STATE OF NORTH CAROLINA DEPARTMENT OF TRANSPORTATION

ADDENDUM # 1

RE: Question & Answer, Plan Sheet Revision, Provision Addition

Contract ID: DN00770
County: Henderson
Letting Date: April 26, 2022

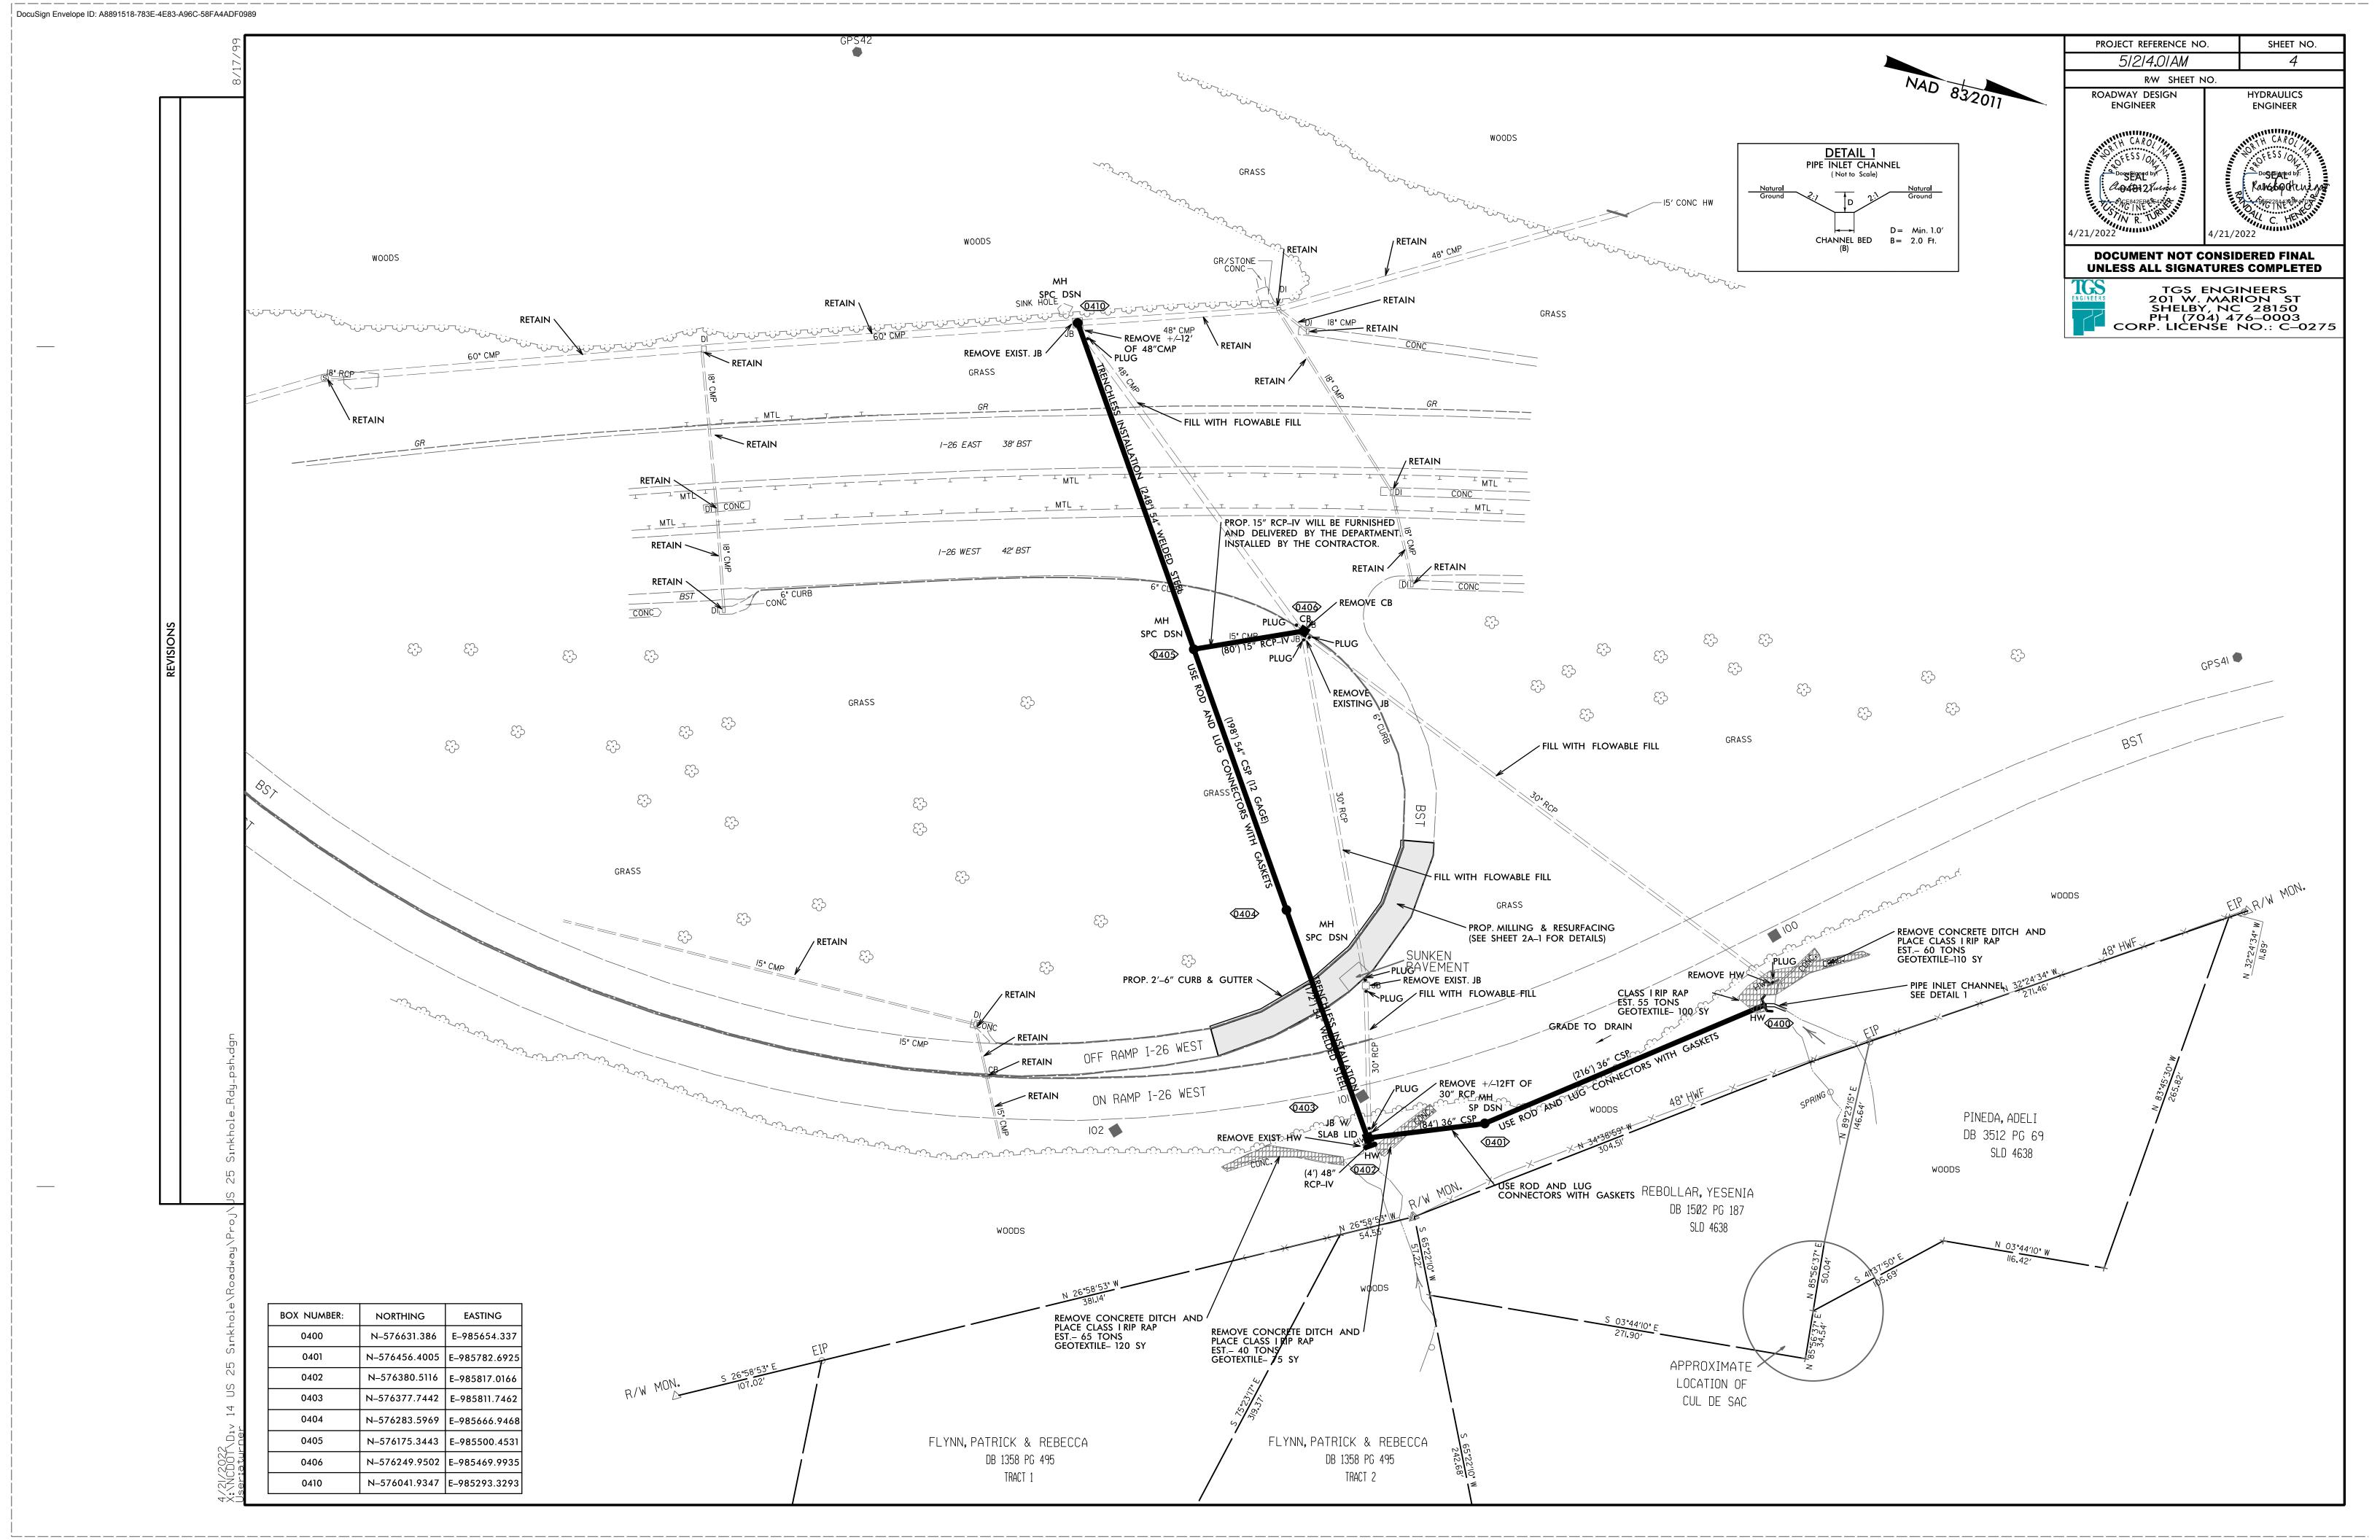
Question #2 – The plans show 80 LF of 15" RCP Class IV, would the department accept another pipe since none of the suppliers have this pipe due to not being able to get the steel.

Answer #2 – The 80 LF of 15" RCP Class IV will now be furnished and delivered by the Department. The Contractor will only be responsible for installation. The unit price for the 15" RCP submitted with your bid should reflect a labor-only cost.

See attached revised **Plan Sheet 4** and **Plan Sheet 3D-1** showing this change.
